RS-00-156

Braidwood Station, Units 1 and 2
Facility Operating License Nos. NPF-72 and NPF-77
NRC Docket Nos. STN 50-456 and STN 50-457

Byron Station, Units 1 and 2
Facility Operating License Nos. NPF-37 and NPF-66
NRC Docket Nos. STN 50-454 and STN 50-455

Subject: Response to the NRC Request for Additional Information Regarding the
Individual Plant Examination of External Events

Part 1 – Remote (i.e., Outside MCR) Shutdown Strategy at the Byron Station and at the Braidwood Station

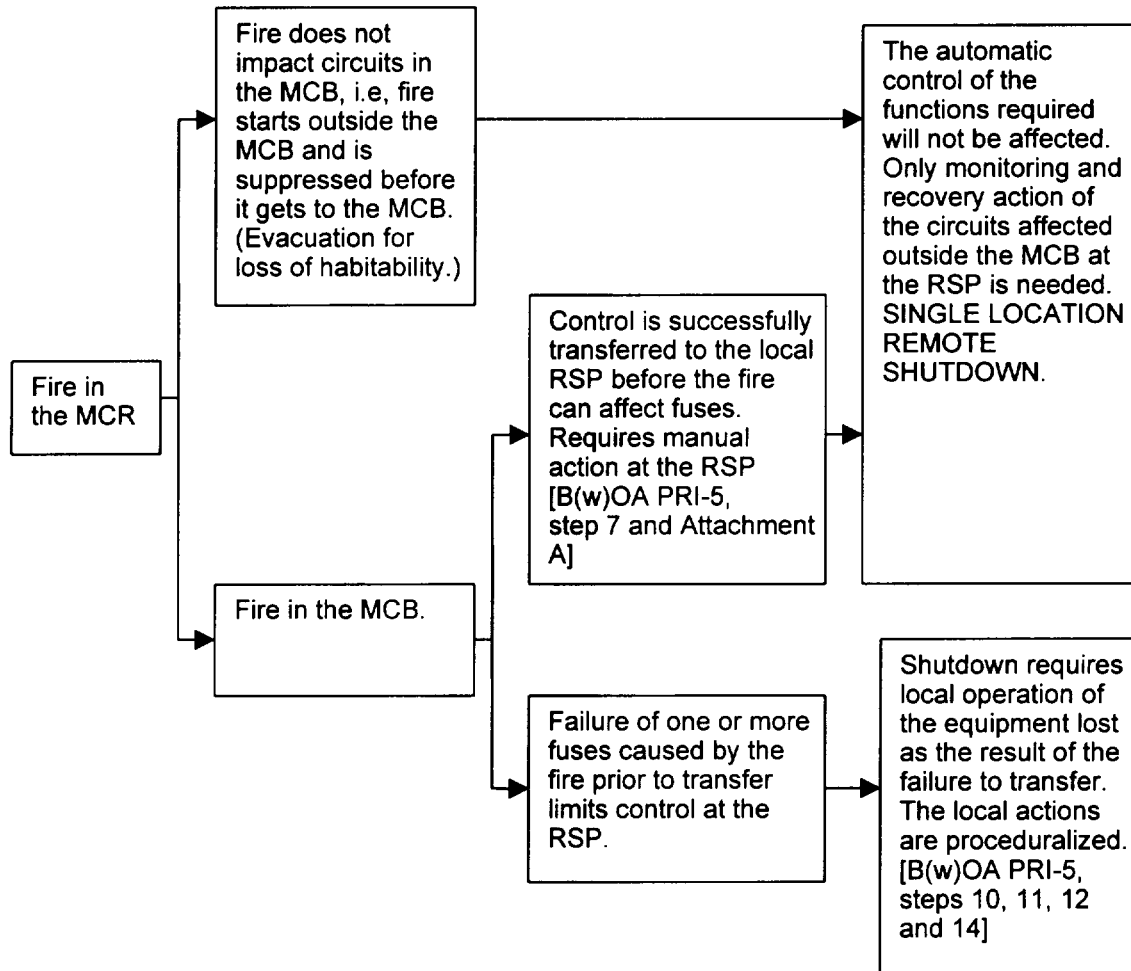
"The remote shutdown process for both Byron and Braidwood is described as involving coordination of a number of proceduralized actions taken from the control room and possibly from multiple remote locations. Throughout the IPEEE fire study the numerical values for remote shutdown CCDPs (i.e., the conditional probability of failure to control the plant during remote shutdown operations) appear to be optimistic for such a distributed shutdown effort requiring actions in multiple plant locations. The values also appear optimistic in comparison to analysis results for other plants, even including plants with localized remote shutdown capabilities that do not require significant actions in other than a single location. It is also not clear which control room abandonment scenarios have been included in the final CDF quantification. For example, the previous RAI responses state that MCR abandonment may occur due to fires in the AEER, but it is not apparent that any such scenarios have been quantified. Hence, it is not possible to determine how important the assumed reliability of remote shutdown was to the quantification of fire CDF at either plant.

Please describe in greater detail the actions required to achieve safe shutdown given abandonment of the MCR (e.g., what functions, controls and indications are available to support remote shutdown operations, what specific actions must be taken, where does each action take place, what is the time frame available to complete the actions, what are the consequences of failure to complete each action in a timely manner, how are actions coordinated, and what training is provided to the operators with regard to remote shutdown actions). Describe the human reliability analysis (HRA) analysis that was performed to assess the reliability of these actions. Justify the assumed remote shutdown reliability estimate (0.003 failure probability) or provide a revised estimate of remote shutdown reliability. Identify all of the fire scenarios that might lead to MCR abandonment and a reliance on remote shutdown. Describe how each such scenario was quantified (or screened) and quantify the total contribution of such scenarios to plant fire CDF. Evaluate the change in the fire CDF if the remote shutdown failure probability is arbitrarily increased by one order of magnitude."

As stated in the response to RAI question 4 in the Reference 1 letter, control capability is available at a number of locations following a fire that requires MCR abandonment and plant shutdown from outside the MCR. However, use of all of these remote panels is not needed for every fire that requires ex-MCR shutdown.

The Byron and Braidwood Stations' fire IPEEE assumes that Hot Standby (i.e., Mode 3) conditions need to be maintained following a MCR evacuation (Ref. 3, pages 4-75 and Ref. 4, pages 4-67 respectively). Hot Standby represents $K_{\text{eff}} < 0.99$ and $T_{\text{avg}} \geq 350$ °F per the Byron and Braidwood Stations' Technical Specifications. The Remote Shutdown Panels (RSPs) 1/2PL04J, 1/2PL05J and 1/2PL06J at the Byron Station and the Braidwood Station provide control functions needed to achieve Hot Standby after a successful transfer to local control at the RSPs. A fire in the Main Control Board (MCB), however, may result in control circuit fuses blowing prior to the transfer switches being aligned for local control at the RSP, resulting in failure to transfer the control functions to the RSP.

Therefore, remote shutdown for the Byron Station and the Braidwood Station can be performed at the RSP except for a fire that spreads through the MCB causing failure of transfer. This scenario was included in the response to question 2 in the Reference 2 letter.

Figure 5-1 - Layout of the Main Control Rooms and AEERs at Byron and Braidwood

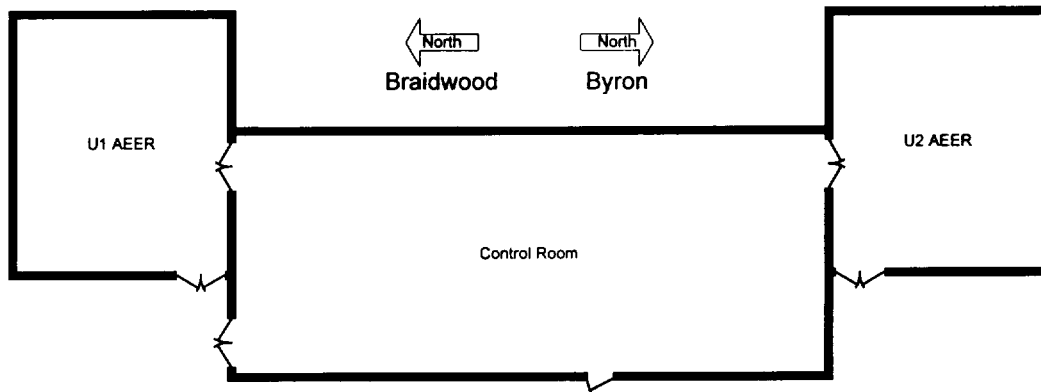
"In the original IPEEE submittal and in the licensee's responses to original fire RAIs #1, #2, and #3, the AEER was likened to a control room in terms of cabinet functions and cabinet contents. Original fire RAI #3 specifically asked whether complications related to control of the plant due to AEER fires resulted in MCR evacuation scenarios. The question concerned both the loss of control of systems from the control room ("controllability") as well as smoke migration into the control room that could necessitate evacuation ("habitability"). The RAI response indicated that for AEER fires, plant control issues were addressed through a combination of actions within the MCR as well as outside of the control room. Numerical evaluations in Table 17-3 are presumed to already include these actions. The responses to the original RAIs are acceptable on this point (controllability). However, with regard to habitability concerns, smoke migration into the MCR from postulated AEER fires, according to the RAI response, is precluded by seals and dampers. Plant drawings appear to indicate at least one doorway between each AEER and the MCR. Also, testing of the seals during licensing was mentioned, but no maintenance or later validation testing was described. Finally, fire doors and penetration seals are designed to preclude the spread of fire and flames, but may allow for the spread of smoke and toxic gasses. For penetration seals, decomposition of the seal materials themselves may lead to toxic gas production on the protected side of the barrier.

Please state whether or not there are doorways between the AEERs and control room. If such doorways do exist, provide a description of the doors and discuss how the potential for smoke or toxic gas spread through the doors was addressed. Estimate the fire CDF contribution if it is assumed that fires in the

This question is related to migration of smoke from the AEER into the MCR, leading to evacuation of the MCR. The Byron and Braidwood Stations' MCRs are located on the 451 foot elevation of their respective Auxiliary Buildings. The AEERs are located directly north and south of the respective MCRs. The relationship of the AEERs to the MCR at both plants is illustrated in Figure 5-1. The MCRs are separated from the AEERs by 12-inch-thick masonry walls carrying a 3-hour fire rating. The MCRs communicate with the AEERs via double doors in the northwest and southwest corners at Byron Station and via double doors in the northeast and southeast corners at Braidwood Station. The doors are Label "A" rated fire doors (Ref. 6).

In the event of a fire in the AEER, several mitigating factors prevent smoke from causing evacuation of the MCR. These mitigating factors include,

- i) The primary source of high-density smoke in the AEER is cable insulation. Fire modeling shows that there is a low likelihood for propagation of a fire outside a single panel. Moreover, most cables outside the panels are routed through conduits or from the top of a panel directly up to a ceiling penetration. This configuration requires significant fire growth to cause high smoke levels, particularly to cause smoke to migrate into the MCR.

- ii) Smoke detectors are installed in the AEER and in the ventilation system for early detection and warning in the MCR. The MCR ventilation can then be switched into the purge mode to avoid migration of smoke into the MCR.
- iii) The rated barriers between the AEERs and the MCR may not be smoke tight but can provide adequate time for detection of a fire in an AEER and realignment of the MCR ventilation, in order to remove or slow introduction of smoke, if any, into the MCR.
